Contract #: 04-0120F4Cty: SF/ALA Rte: 80 PM: 13.2/13.9File #: 69.25B**QUALITY ASSURANCE -- NON-CONFORMANCE REPORT****Location:** Changxing Island, Shanghai, P.R. China**Report No:** NCR-000266**Prime Contractor:** American Bridge/Fluor Enterprises, a JV**Date:****Submitting Contractor:** Zhenhua Port Machinery Company, Ltd (ZPMC), Changxing Island**NCR #:** ZPMC-0240**Type of problem:****Welding****Concrete****Other****Welding****Curing****Procedural****Bridge No:** 34-0006**Joint fit-up****Coating****Other****Component:** OBG Crossbeam CB1**Procedural****Procedural****Description:****Reference Description:** Critical Weld Repair Performed Without the Engineer's Approval, CB1**Description of Non-Conformance:**

Job Name: SAS Superstructure

Subject: NCR No. ZPMC-0240

Reference Description: Critical Weld Repair Performed Without the Engineer's Approval, CB1

Report No: NCR-000266

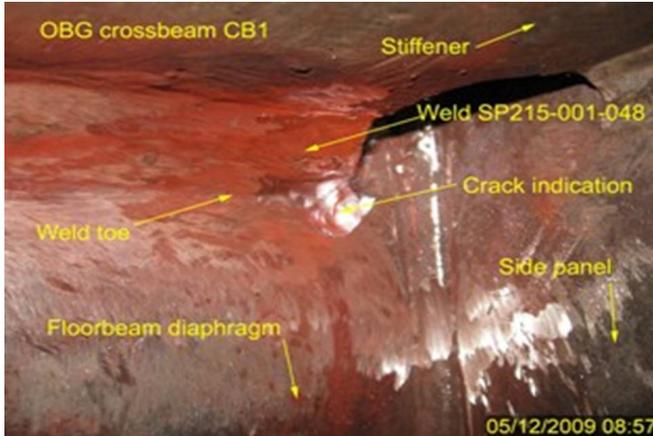
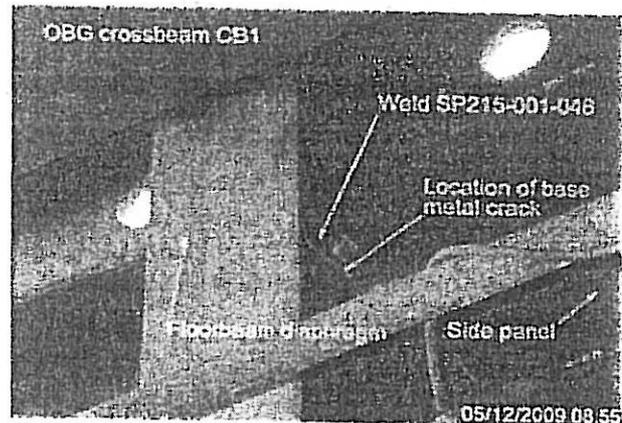
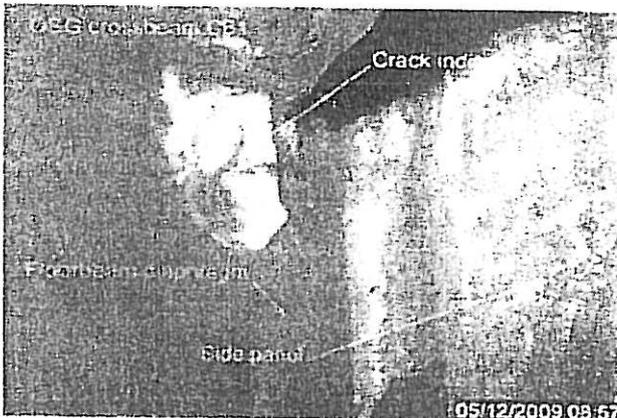
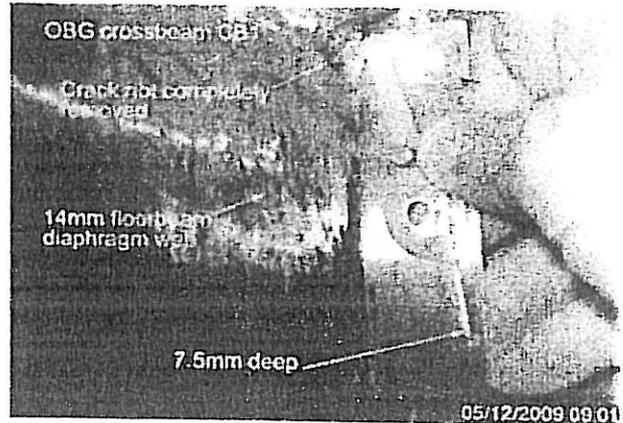
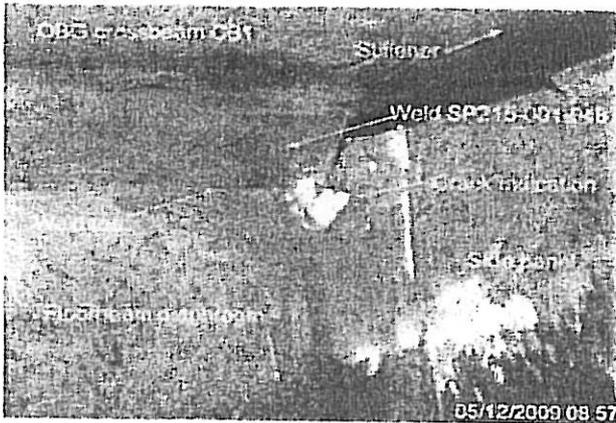
Caltrans Quality Assurance (QA) Inspector observed that the Contractor has performed base metal repair of a linear indication without an approved repair procedure. The Complete Joint Penetration (CJP) weld (SP215-001-048, Crossbeam CB1) in the area of this repair has previously been repaired three times; one time for two toe indications discovered visually on 5/6/09 and two additional times after ZPMC Quality Control (QC) Ultrasonic Testing (UT) technicians rejected the repaired area of the weld. A CWR was provided to the Engineer after the work had already been performed.

AWS D1.5 (2002) Paragraph 3.7.4: "Prior approval of the Engineer shall be obtained for repairs to base metal, repair of major or delayed cracks,"

Please provide documentation of the weld repairs that were performed and that the repairs were acceptable. The Department will review the Contractor's proposal to close Non-Conformance ZPMC-0240 at that time.

Please submit a revised Critical Weld Repair (CWR) report, and acceptable MT and UT reports after the repair. The Department will review the Contractor's proposal to close Non-Conformance ZPMC-0240 at that time.

WELD NUMBER: SP215-001-048

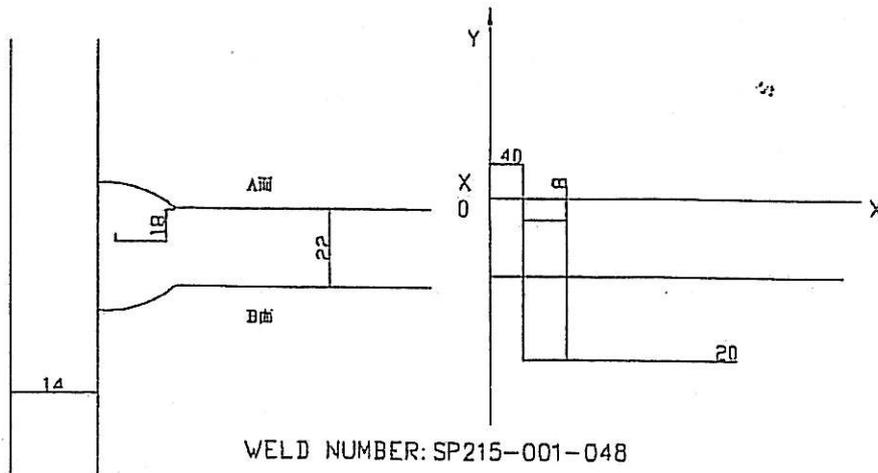
A Rejectable indication was found by Ultrasonic Inspection for a **SECOND** repair. *third*

1. The welder was not observant during the first backgouging operation resulting in the Indications not being completely removed.

2. QC did not verify the indications had been removed prior to re-welding.

1. QC and a Lead CWI shall be present and monitor all gouging, grinding and welding operations during this repair.

2. QC shall have a copy of the CWR available to ensure the repair is per the disposition requirements.

3. If gouging is performed, preheat per the repair WPS minimum requirements.

4. Gouge and/or grind to remove all the defects from the Face A.

5. Prepare the repair joint according to the relevant repair WPS.

6. Grind area smooth to a shiny finish.

7. Perform VT and MT to ensure the defects have been removed.

8. Preheat and weld according to the relevant repair WPS.

9. Perform VT, MT and UT to the repair areas.

10. Grind the weld flush with the adjacent weld.

11. Check the weld according to the working drawings.

项目名称 Project Name:	美国海湾大桥 SFOBB	部件图号 Drawing No.:	CB1	报告编号 Report No.:	B-CWR502
合同号 Contract No.:	04-0120F4	部件名称 Item Name:	扭曲横梁CB1 Cross beam C B1	NDT报告编号 Report No. of NDT	B787-MT-10681
项目编号 Project No.:	ZP06-787

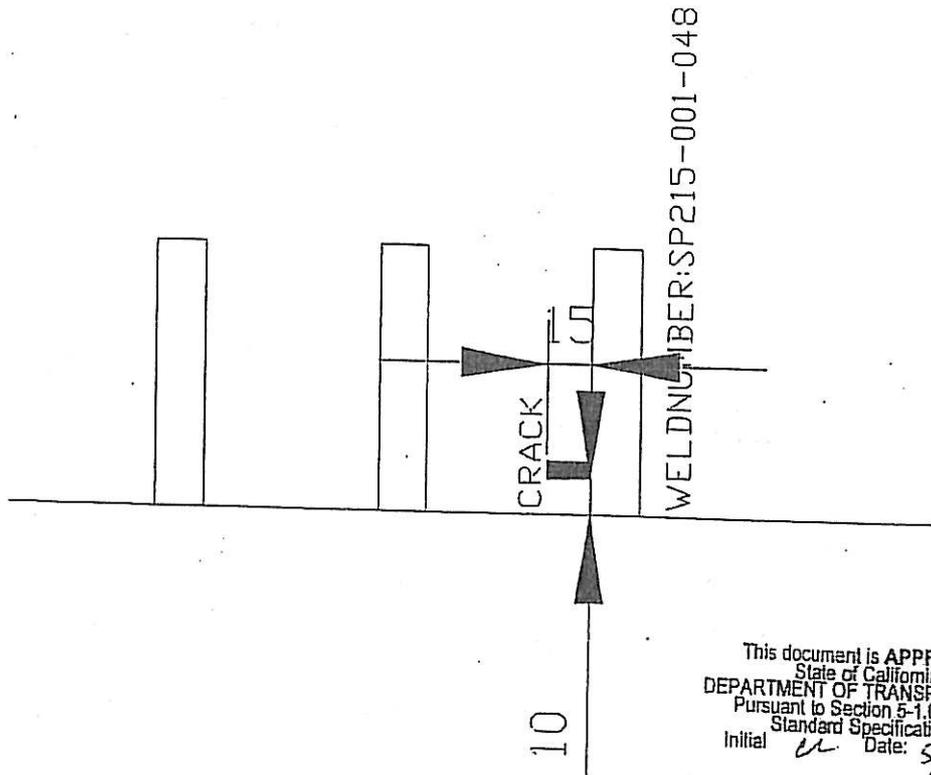
We found one transverse crack in SP215-001-048.

1. 火焰加热时, 水汽没有完全的去掉或者这个区域预热不够;
2. 翻身碳刨清根后, 打磨不到位,。
1. Moisture wasn't completely removed during drying operation (preheating) or the area wasn't preheated sufficiently.
2. It didn't grind smoothly after backing gouging.

1. 这次返修时, QC到现场指导打磨, 焊接;
 2. QC指导返修, 以保证返修按照处理意见进行;
 3. 采用打磨的方式去除裂纹;
 4. 准备一个正确的接头型式, 具体参照相应的返修WPS;
 5. VT和MT检测确认返修区域没有裂纹;
 6. 根据批准的返修焊接工艺规程
 7. 预热温度应不小于100℃,
 8. 预热范围在修补区域周围不应小于150mm;
 9. 将修补区域打磨与母材或相邻焊缝平齐;
 10. 对修补区域做VT与MT检测。
1. QC shall be present and direct all grinding and welding operations during this repair.
 2. QC shall direct the repair to ensure the repair is per the disposition requirements.
 3. Remove the crack by means of grinding.
 4. Prepare excavation according to the approved repair WPS.
 5. Verify with VT and MT repair areas are crack free.
 6. Preheat and weld according to the approved repair WPS.
 7. Preheat prior to welding to a minimum temperature of 100°C
 8. The preheat area shall be a minimum of 150mm in all directions around the repair area.
 9. Grind the repaired area flush with base metal or the adjacent weld.
 10. Perform VT and MT of the repair areas.

WELD NUMBER: SP215-001-048

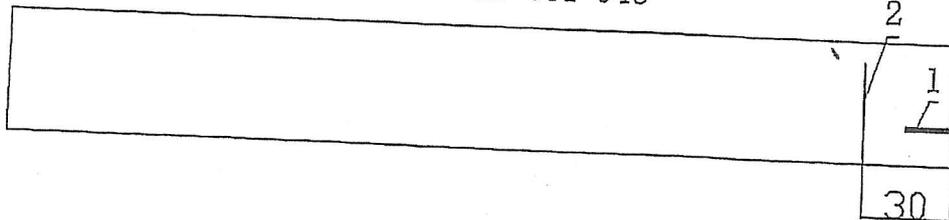
在对SP215-001-048检测时, 发现2处裂纹。1、L=15 L2=10mm;
Welder ID No. (焊工编号): 2#6667 Position:(位置): 2F
One crack found by use of MT on weld SP215-001-048

1. 火焰加热时, 水汽没有完全的去掉或者这个区域预热不够;
1. Moisture wasn't completely removed during drying operation (preheating) or the area wasn't preheated sufficiently.

1. QC and a Lead CWI shall be present, direct and supervise all grinding and welding operations during this repair to ensure the repair is per the disposition requirements

2. QC and a Lead CWI shall have an approved copy of the CWR in hand prior to the repair.
 3. Remove paint ≥ 25 mm in all direction of HAZ prior to MT.
 4. Remove cracks by grinding, repair area shall extend a minimum of 50mm beyond each end of single crack repairs;

5. If base metal is damaged by grinding, the damaged area shall be ground clean prior to performing weld repair. If gap > 5 mm is found during or after grinding, a separate CWR to make the weld joint a CJP is required in that location, and perform MT after performing grinding the defects away.

6. Prepare excavation in accordance with an approved repair WPS prior to welding.
 7. Before this repair, Verify with VT and MT repair areas are defects free;

8. Perform MT on the weld metal adjacent to the repair area to ensure that crack did not propagate into base metal. If crack is discovered in base metal, approval of a separate CWR is required before continuing with repair work.

9. Preheat and weld according to the approved repair WPS.
 10. Grind the repaired area flush with base metal or the adjacent weld.
 11. Perform 100%VT and MT inspection to all repaired welds (along with an additional 50mm at each end of the weld repair) which include the near side and far side on the upper Perform UT and MT inspection to CJP weld.

项目名称 Project Name:	美国海湾大桥 SFOBB	部件图号 Drawing No.:	CB1	报告编号 Report No.:	B-CWR509
合同号 Contract No.:	04-0120F4	部件名称 Item Name:	OBG CROSS BEAMS	NDT 报告编号 NDT Report No.:	B787-UT-6536R1
项目编号 Project No.:	ZP06-787

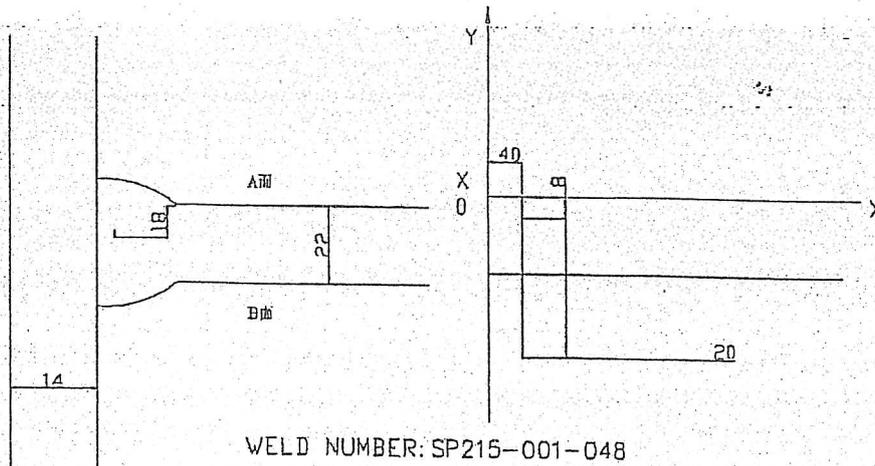
A Rejectable indication was found by Ultrasonic Inspection for a **SECOND** repair. *third*
(UT二次缺陷) SP215-001-048

1. 焊工在第一次反面清根时, 没有注意, 导致焊接缺陷没有全部去除;
 2. 在焊返修前, QC没有确认所有的焊接缺陷已经去除。
1. The welder was not observant during the first backgouging operation resulting in the Indications not being completely removed.
 2. QC did not verify the indications had been removed prior to re-welding.

6. 将缺陷区域打磨平滑;
 7. 采用MT和VT检测方法保证缺陷完全被消除;
 8. 预热及焊接要求参照已批准的返修WPS执行;
 9. 返修后,VT,MT,UT检测焊缝;
 10. 将焊缝打磨与相邻焊缝平齐;
 11. 根据批准的车间图纸检查焊缝;
1. QC and a Lead CWI shall be present and monitor all gouging, grinding and welding operations during this repair.

4. Gouge and/or grind to remove all the defects from the Face A.
 5. Prepare the repair joint according to the relevant repair WPS.
 6. Grind area smooth to a shiny finish.

项目名称 Project Name:	美国海湾大桥 SFOB	部件图号 Drawing No.:	CB1	报告编号 Report No.:	B-CWR502
合同号 Contract No.:	04-0120F4	部件名称 Item Name:	扭曲横梁CB1 Cross beam C B1	NDT报告编号 Report No. of NDT	B787-MT-10681
项目编号 Project No.:	ZP06-787

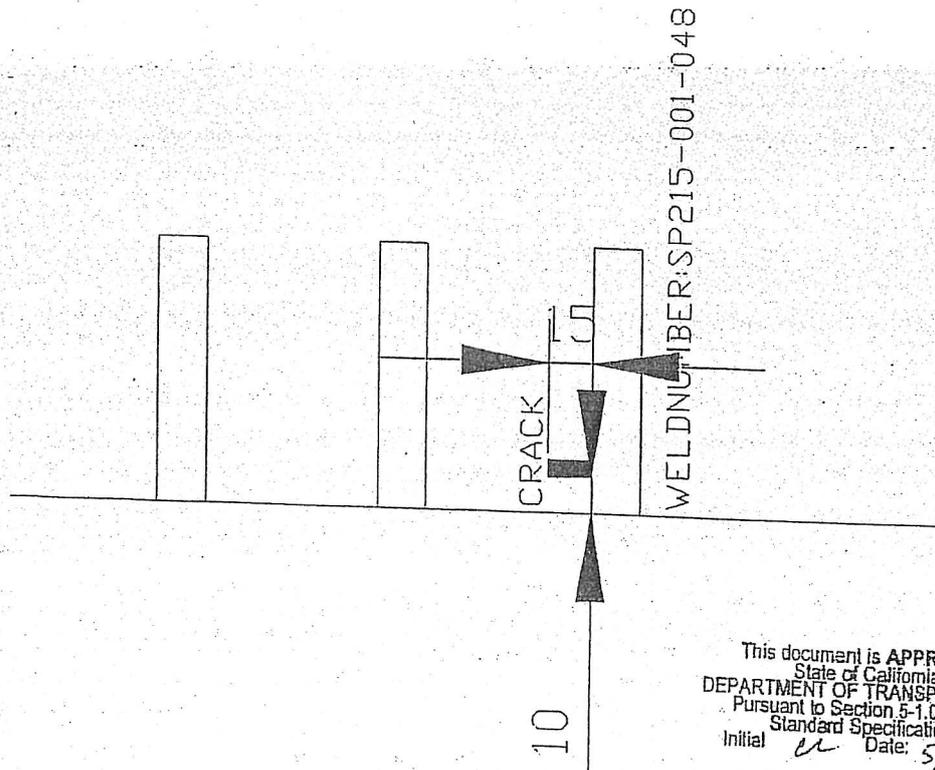
We found one transverse crack in SP215-001-048.

3. Remove the crack by means of grinding.

5. Verify with VT and MT repair areas are crack free.
